**CITY OF ALLENTOWN
HISTORIC ARCHITECTURAL REVIEW BOARD
FINAL REVIEW SHEET
May 7, 2018**

ITEM #5 – Case #HDC-2018-00017 – Proposal to add 3rd story to existing 2 story building

Property located at: 1031 Linden St.

Circa 1934, The Morning Call:

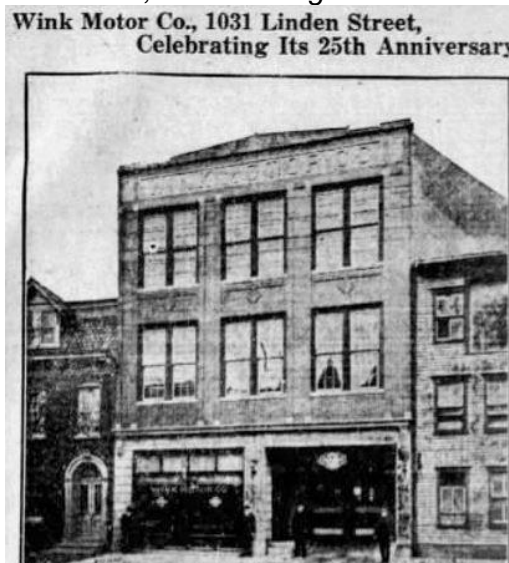
The proposed addition is historically appropriate in concept. As seen in the historic image there were originally no windows on the side since it was a party wall abutting an adjacent building. This condition has changed and replicating the second floor windows and stucco on the side is historically appropriate.

The front windows need some discussion based on the historic image. The multi-light, 12 over 12 configuration of the historic windows may be a more appropriate direction for the third floor windows since there is photographic evidence for them. In the future, if funds do not presently exist for it, the second floor windows might be replaced with the same to recreate the

historic appearance. It is also recommended that the glass block be replaced in the future with something more closely resembling the historic storefront condition, if possible. Architectural drawings including elevations of both front and side with material specifications/call-outs should be provided in addition to the rendering.

Discussion: The applicant said he would be willing to install 12 over 12 double hung windows on the third floor in the front. He was not sure he would have the money to replace the existing 2nd floor windows at this time and asked not to be required to do so. The size of the mullion between the new 12 over 12 windows was studied and 6" recommended as historically correct. There was also a concern from the applicant that there were no companies that could provide such a big window. The Historic Consultant said they were available, but might need to be single hung windows. A manufacturer was suggested as one that had the larger sizes. The side windows were also studied. The existing windows are fixed or fixed with awnings. The applicant said they planned to use casements which it was agreed would look very similar to the existing. The extent of the work on the side and rear was verified. The HARB asked the applicant to provide typical 2D architectural drawings of the proposed work and new windows.
